The home at 11236 Race Street in the College Meadows subdivision (Lot 52, Third Plat) was completed in December 2016. Following construction, the home flooded in 2017, 2021, and 2024 and the homeowners have incurred significant costs for cleanup and repair of damages. The following is the timeline of the flooding and the actions taken:

Design Review by David Silverstein

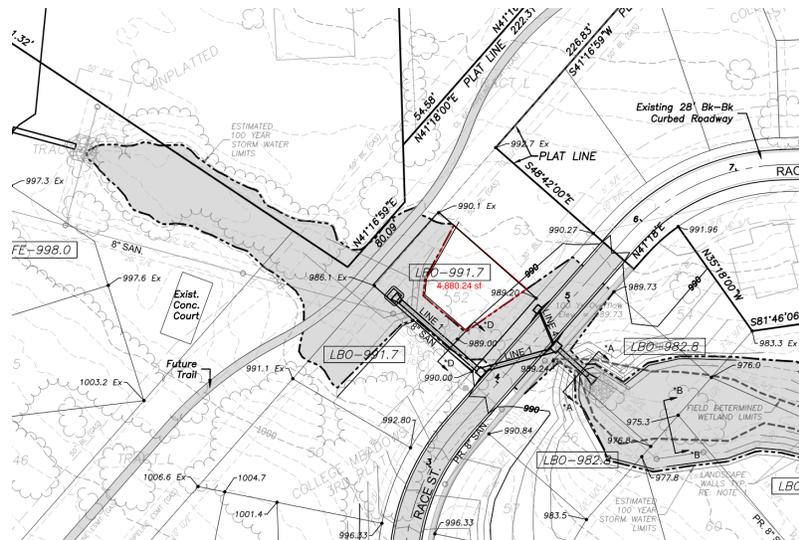
Street and storm sewer plans for the 3rd Plat were developed in 2014 by Gary T Spehar Engineering and Planning, and the storm sewer plans called for replacement of the channel through Lot 52 and under Race Street with a 48" diameter HDPE pipe as shown below. The pipe was to have a flared end section at the upstream end, and it was

designed to convey runoff flows from the 10-year storm and a portion of the flow from the 100-year storm. The remainder of the flows from the 100-year storm were to be conveyed over land and across Race Street with a depth of less than 6".

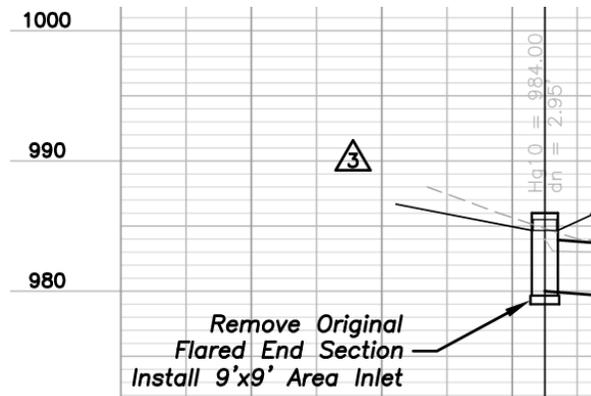
The grading plan shown below was prepared by the engineer and it shows the extent of potential flooding during the large storm events. It indicates that nearly 55% lot 52

was predicted to be flooded with only the footprint of the future home above the flood level. Lot 51 shows similar flooding, though not to the same extent.

The grading plans also show that the future home should have a low building opening (LBO) of 991.7' to avoid direct entry of flood waters into the home. This LBO would have required the first-floor elevation of the home to be approximately 995' or six feet higher than the street grade in front of lot 52. Grading the lot to achieve this would have been very difficult and undesirable for a future homeowner.

Figure 5: Pond Elevations

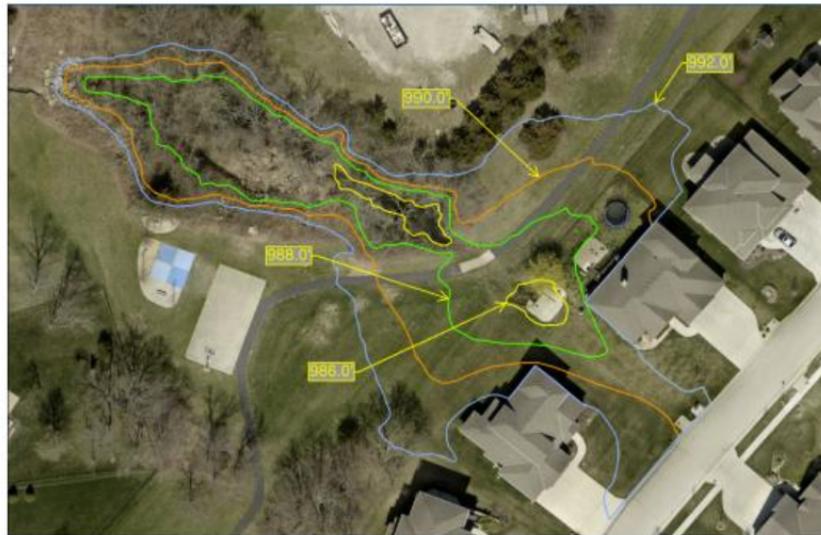
The analysis concluded that the backyards of lots 51 and 52, in combination with the field inlet and the low area to the west, were acting as a detention pond for stormwater flows up to 992' as shown in the screen capture from the report shown on the following page. It also concluded that the home flooded because it was built 2.46' lower than the proposed elevation shown in the development plan and water could enter through the LBO prior to construction of the window well extension. The analysis also identified several discrepancies associated with the design of the stormwater system including:

- The area inlet and 48" pipe are undersized due to differences in watershed area and time of concentration
- The street overflow weir was not constructed as designed. This results in a higher headwater elevation than shown on the plans.
- The Race Street crossing was modeled as a culvert, not an enclosed system with consideration of the hydraulic losses associated with the curb inlets and bends.
- Replacement of the flared end section with the field inlet did not affect the peak flood stages, but it contributes to inundation of the owner's lot during more frequent events.

These discrepancies resulted in larger flows and higher flooding elevations for the 10- and 100-year events than shown by the design engineer.

HNTB's analysis showed that flooding could be relieved by replacing the 48" pipe and inlet with an 8' x 4' concrete box culvert and new field inlet with open cell grating on the top. The box culvert has nearly 3 times the cross-sectional area of the 48" pipe. The cost of the improvements was estimated to be \$466,000.

Historic and Expanded Storm Drain System Under College Blvd.

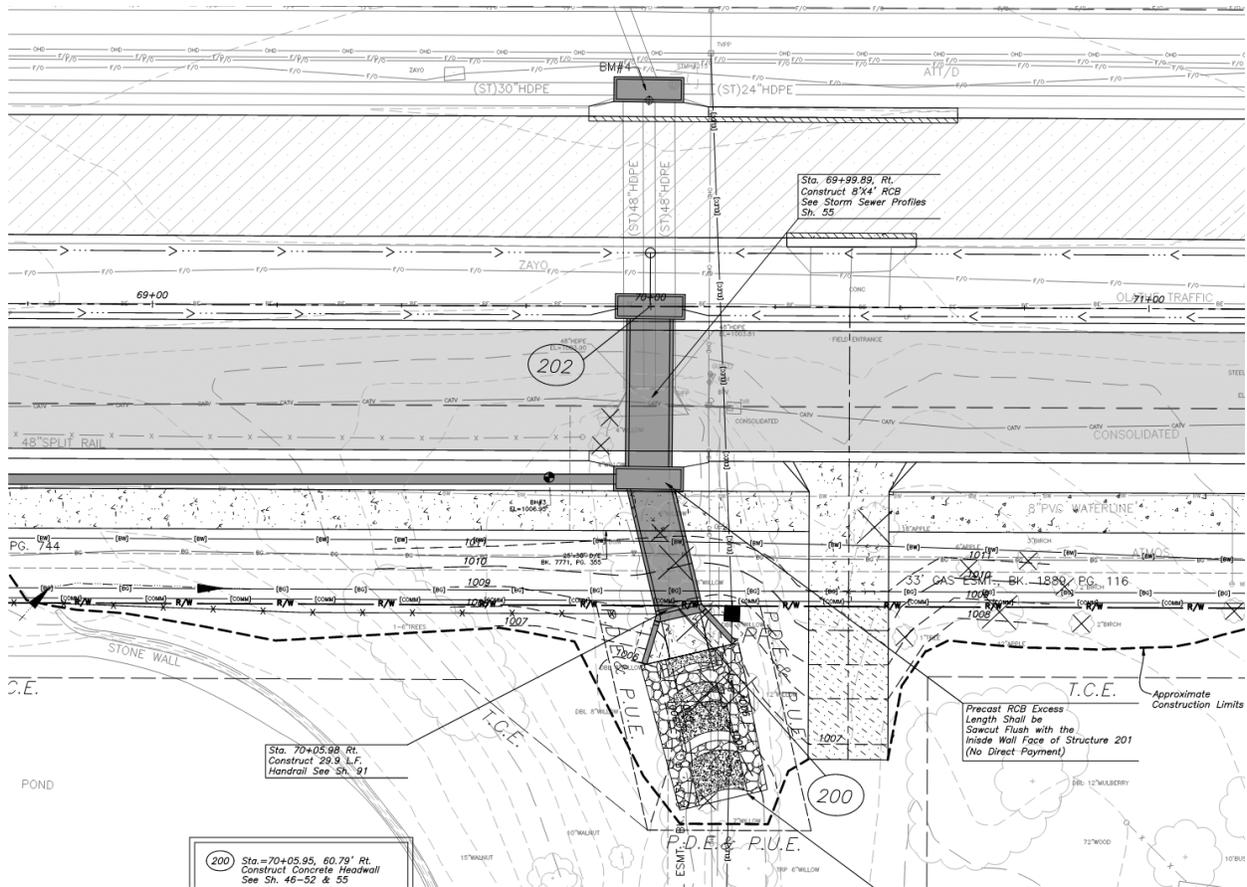
1. The road was widened to 4 lanes with turn lanes, a raised median and a bike path on the south side of the expanded road. The addition of these features more than doubled the previous and semi-impervious surface associated with the road. Approximately 2 acres of impervious surfaces were added by the road expansion.
2. Approx. 2000' of the expanded road is contained within the watershed upstream of the development and runoff from the road is collected in an expanded storm drainage system as shown below. The 2-48" RCPs under the westbound lanes are now connected to an 8' wide by 4' high RCB under the eastbound lanes.
3. No provisions appear to have been included in the design to mitigate the effect of the increased impervious surfaces on downstream flows.

Hydrologic and hydraulic modeling would be required to determine the effect of road expansion on peak runoff rates. However, it is logical to conclude that the increase in the impervious surface area and the construction of an expanded enclosed storm drain system would result in increased flows seen in the downstream system at Race Street. The design engineer would not have taken this into account when preparing the plans for the subdivision because the road was not designed until after the subdivision was permitted.

Figure 1: Proposed Berm

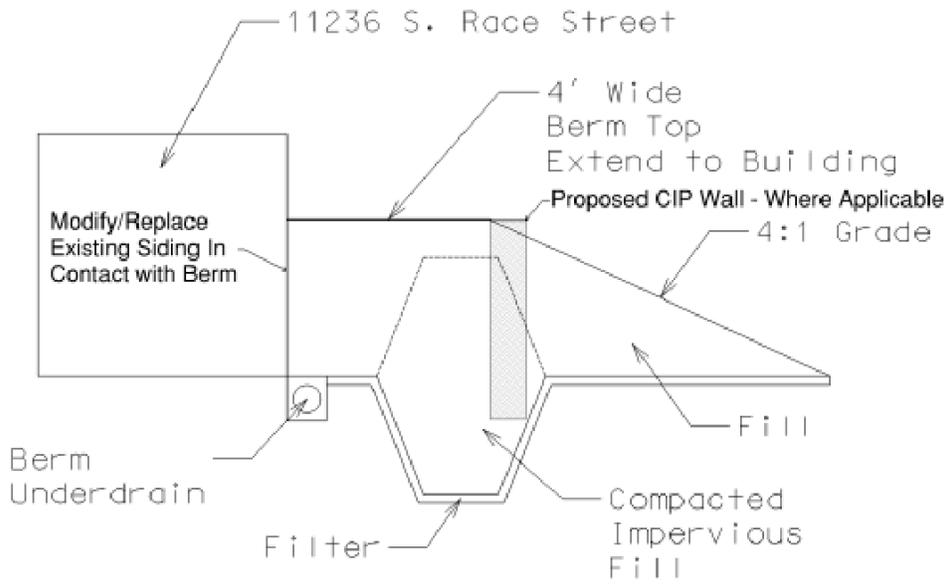
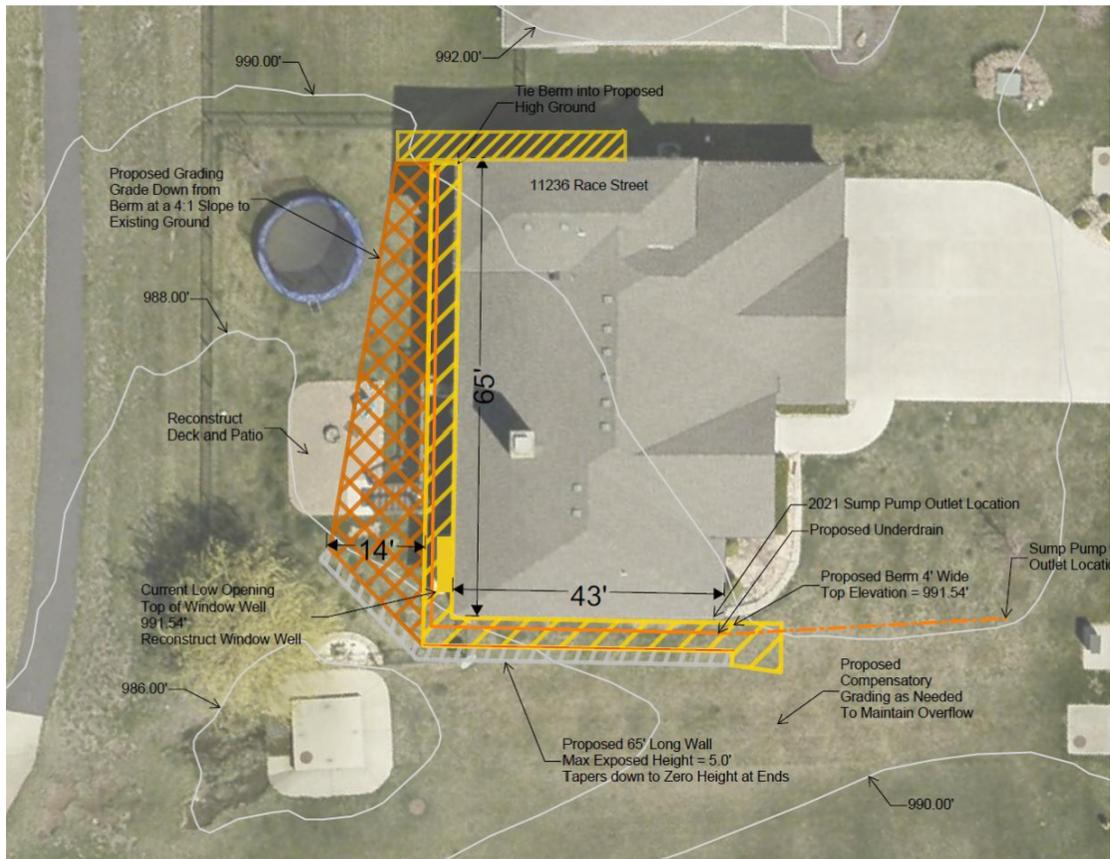
The estimated cost of the improvements is \$140,000 and the city proposed spitting the costs with the owners. Although the improvements are potentially feasible, they are undesirable for the following reasons:

- The root causes of the flooding are not being addressed. The owner's yard will continue to flood during large storm events.
- The berm and wall will make a large portion of the back and side yards unusable.
- The existing deck and patio will have to be torn out and the patio will have to be located near the rear fence.
- The proposed improvements will not guarantee that water will not intrude into the home.
